# Hatton Square

Application Ref: 2013/5404/P Information to support omission of living wall

**Document number:** 203-A-REP-PC-01

#### Proposed Omission of Living Wall

Consented South Elevation showing green screen areas

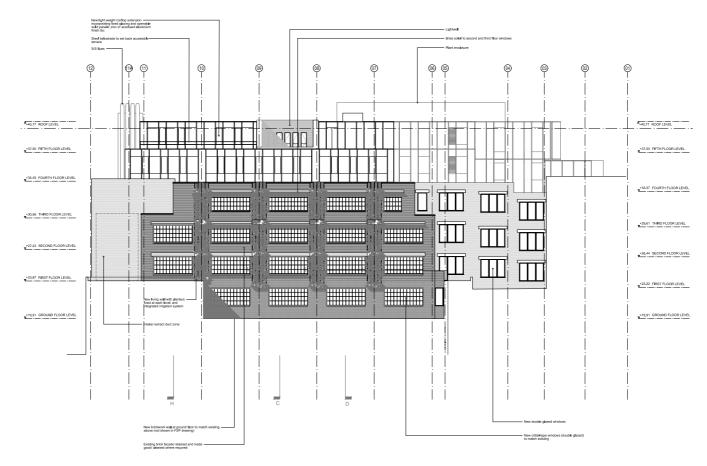
Investigation of the proposed living wall areas to the South Elevation has suggested that providing access to regularly maintain it would be difficult to achieve in such a closed off area. It is therefore proposed to omit the living wall, and focus on achieving the ecological enhancements to the site through the green roof areas.

The living wall was previously proposed as a pre-grown ivy 'green screen' system, typically grown as a monoculture that has a guaranteed survival rate. The ivy grows from a planter mounted on the wall and is supported on a metal mesh.

As this system consists of a single species, it makes a negligible contribution to increasing the species diversity and enhancing the ecological value of the site, at an estimated species value of 1 per hectare covering around 64m2 of wall fully grown.

In contrast, approx 310m2 of biodiverse green roof has been installed, using a combination of a pre-grown wildflower blanket, with additional plug plants at a minimum density of 12 plants/m2 (see Specification by the Green Roof Consultancy). The biodiverse roof achieves the maximum number of BREEAM credits available for both LE04 - Mitigating Ecological Impact, and LE05 - Enhancing Site Ecology.

Using a biodiverse green roof with a species richness of 46 species/Ha in the areas as shown results in a species change score of + 8.13, (a minimum score of + 6 is needed to achieve all three of the BREEAM LE05 credits).
